RECORD OF DECISION FINAL 94901
PHOENIX-GOODYEAR AIRPORT
SUPERFUND SITE
GOODYEAR, ARIZONA

Appendix B RESPONSE SUMMARY

EPA received comments during the public comment period for the June 1989 Draft RI/FS report. The public comment period was held from June 7 through July 7, 1989. Comments were received from state agencies, potentially responsible parties, and members of the community. EPA also received comments at the Public Meeting held on June 21, 1989, at the Goodyear Community Center. All comments received are responded to herein.

FIGURE 5-1
TARGET AREA 1
FOR SOILS REMEDIAL ACTION
AT PHOENIX GOODYEAR AIRPORT
AND FORMER GAC FACILITIES
PHOENIX GOODYEAR AIRPORT ROD

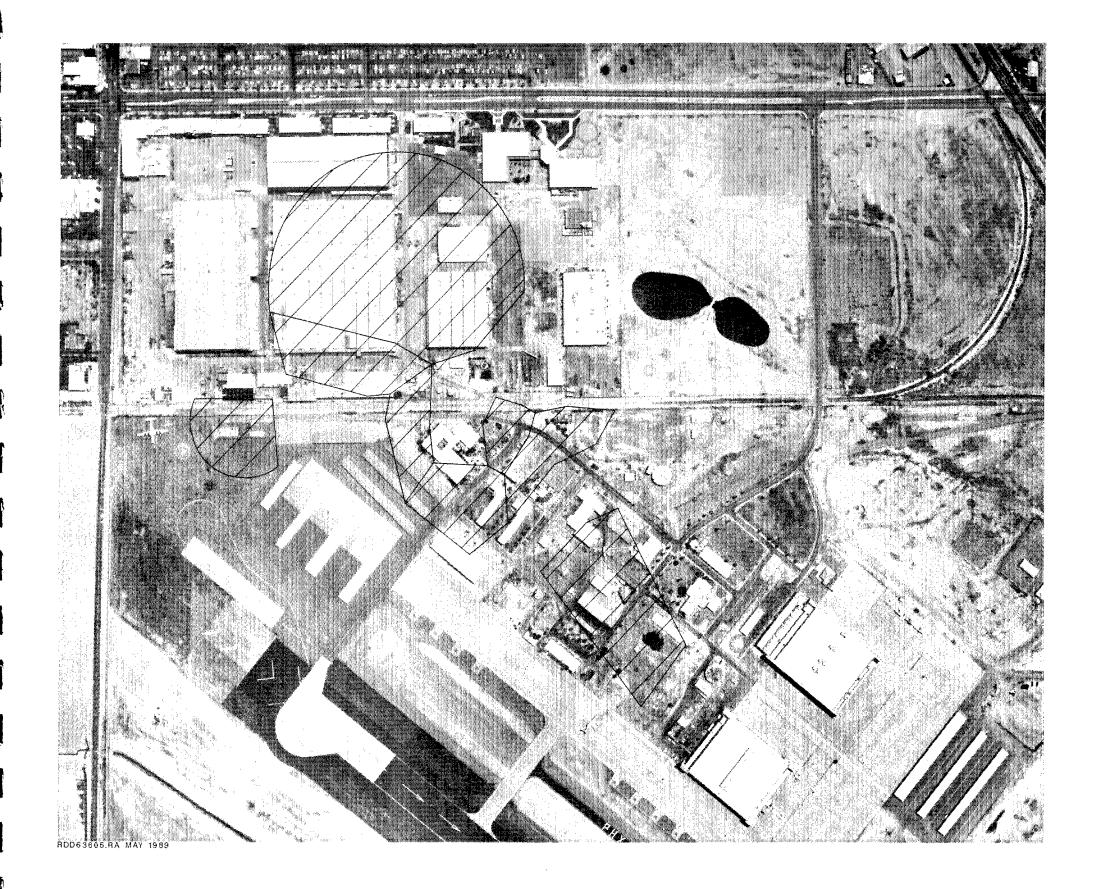
# 2. CHAPTER 5, FIGURE 5-1

FIGURE 5-3
TARGET AREA 3
FOR SOILS REMEDIAL ACTION
AT PHOENIX GOODYEAR AIRPORT
AND FORMER GAC FACILITIES
PHOENIX GOODYEAR AIRPORT ROD

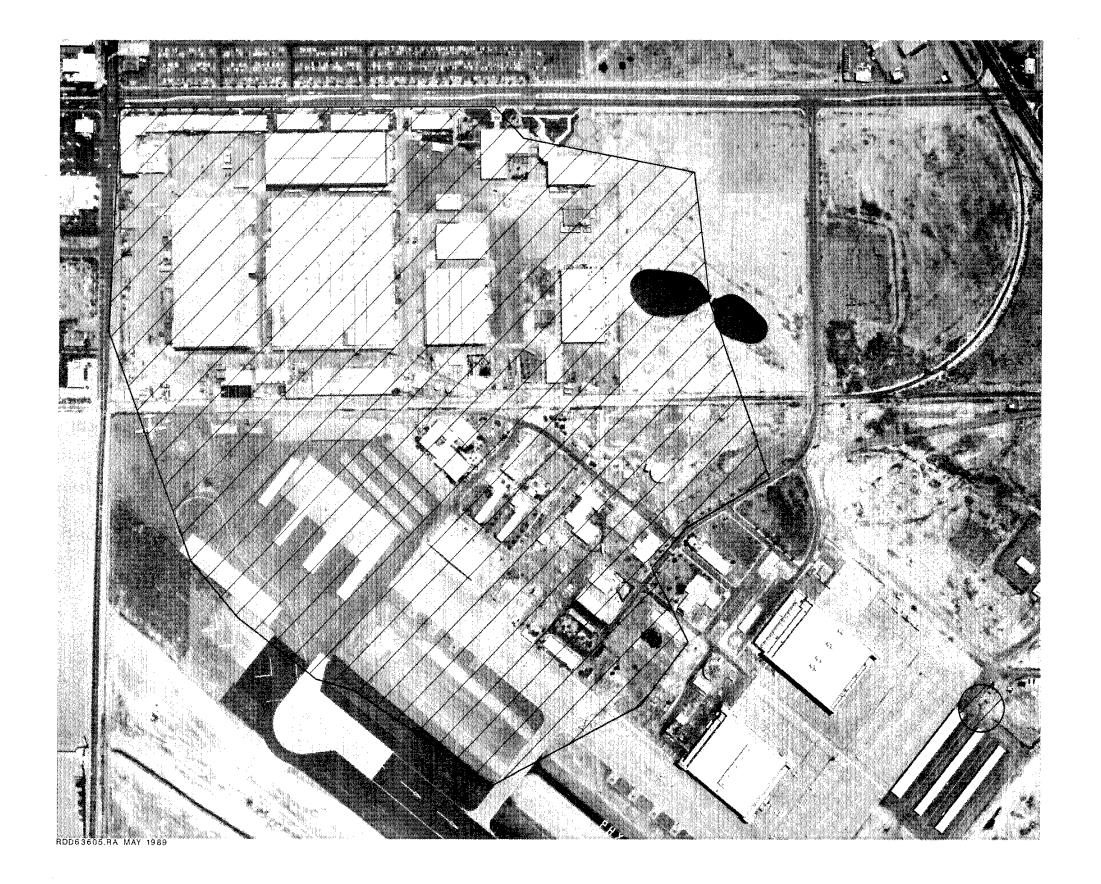
#### 5. CHAPTER 5. FIGURE 5-3

These items may be included during the remedial design phase. No change to Figure 5-3 has been made.
